B I A M P[®]
S Y S T E M S

Service Bulletin

GUIDES AND MODIFICATIONS FOR THE TC/60 & TC/120

TC/60 and TC/120

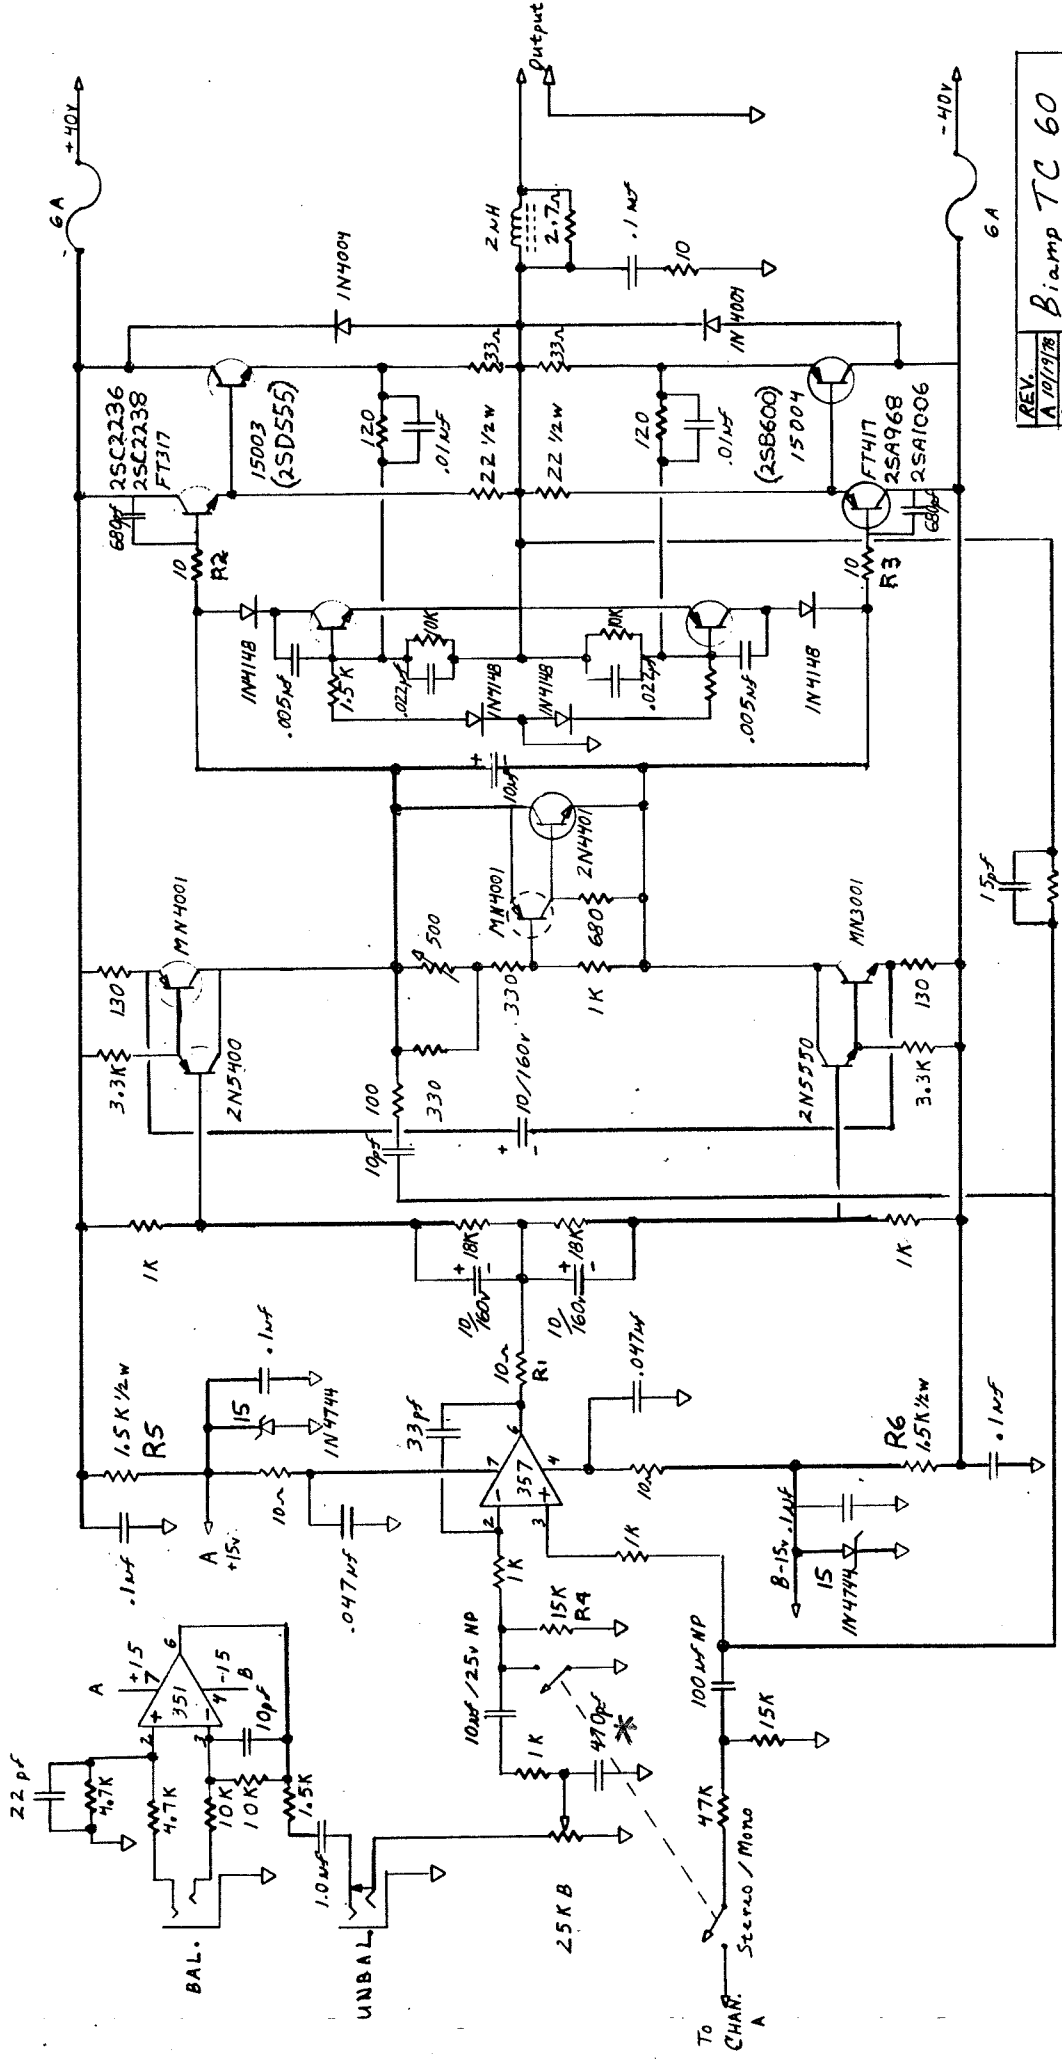
EARLY TC/60 AMPLIFIERS only:

Resistors R5 and R6 are 1500 ohm, $\frac{1}{2}$ watt components. These have proven to be under-rated and should be replaced with 1 watt resistors any time these units are serviced.

The trouble symptom for failure of either of these resistors is D. C. voltage on the speaker terminals.

The LF357 input IC was changed during production to a 5534 IC. This change requires that R4 also be replaced with 47,000 ohm resistor.

D.C. voltage on the speaker terminals can originate anywhere within the circuit. Isolation of stages is possible by lifting on end of both R2 and R3. When these resistors are lifted the D.C. voltage across the speaker post terminals will be about 0.5 volt D.C., no load. If this voltage is correct the driver and output transistors are OK. Reconnect ~~R2~~ and ~~R3~~.

REV.	DATE	BY
A	10/19/78	Blamp TC 60
B		Drawing JOHN PAYNE
C		Design DALE SLIGER
D		
E		
F		
G		
H		Beaverton, Ore.

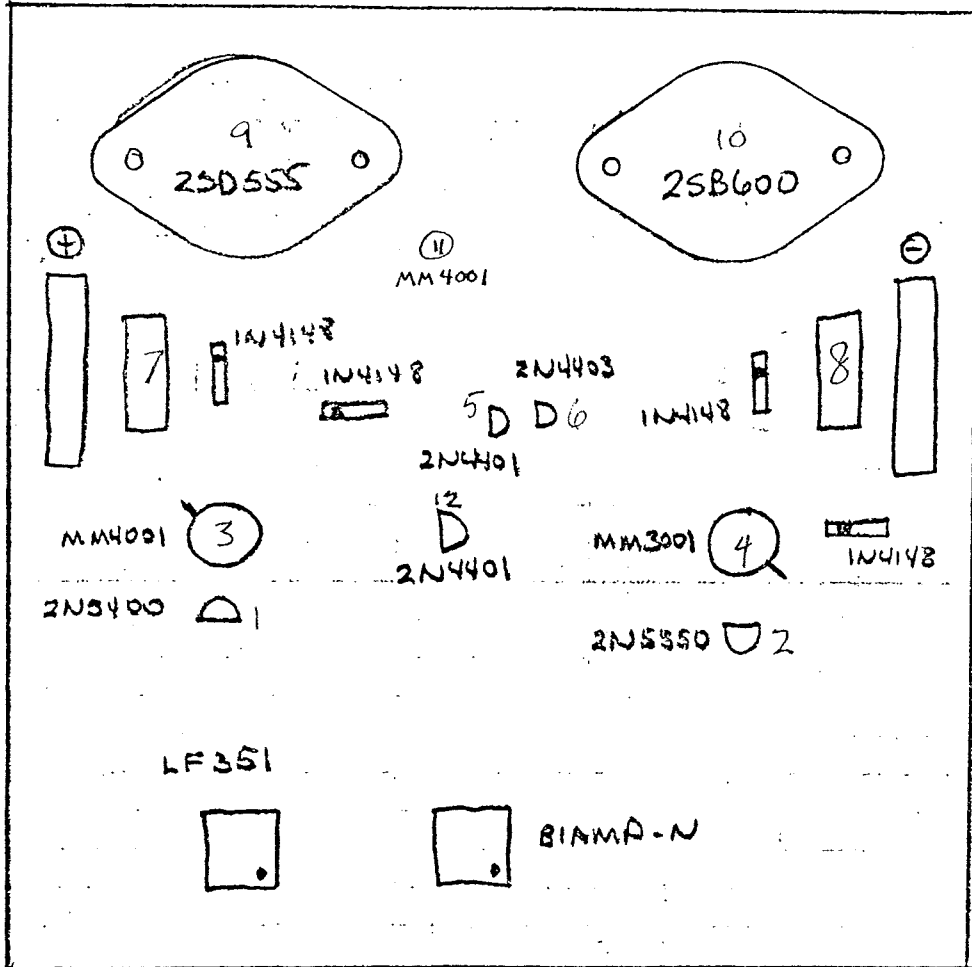
NOTE: IF OSCILLATION OCCURS AFTER TWEET-OFF
 47µF CPP MARKED * IS MISSING

Biamp TC 120
 Drawing JOHN PAYNE
 Design DALE SLIGER
 Beaverton, Ore.

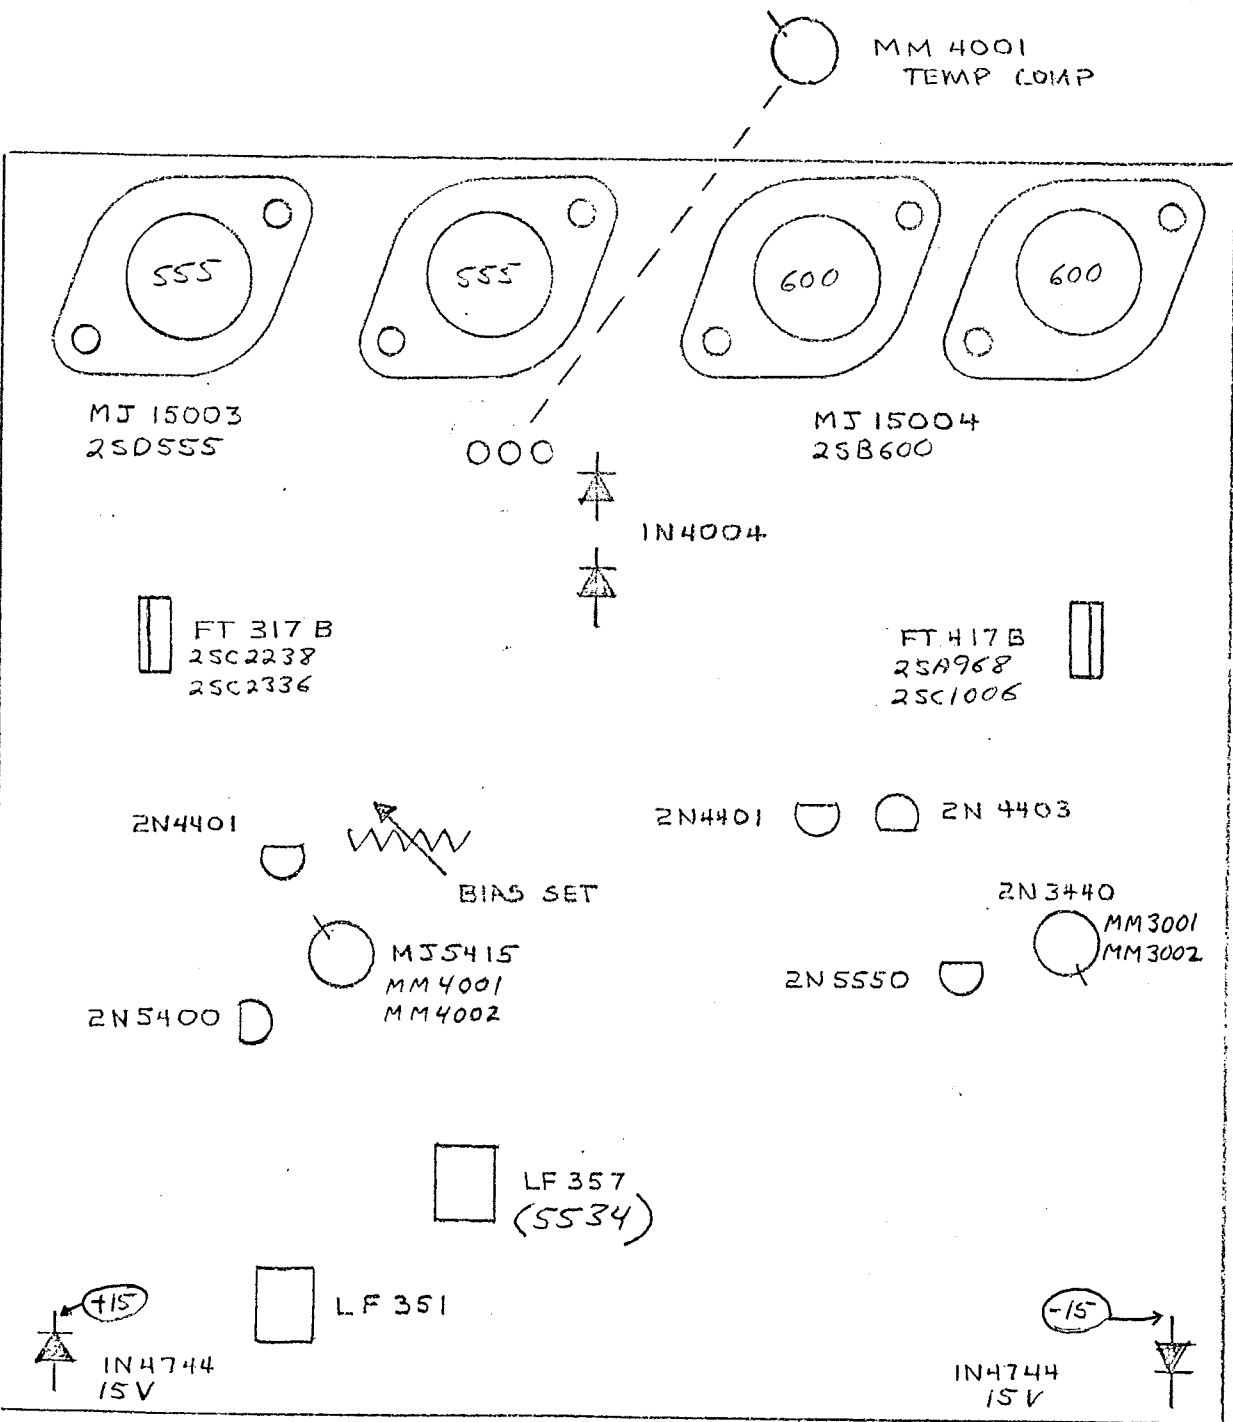
Note: If oscillation occurs AFTER Turn-off
 Then the 470pf cap marked * is missing
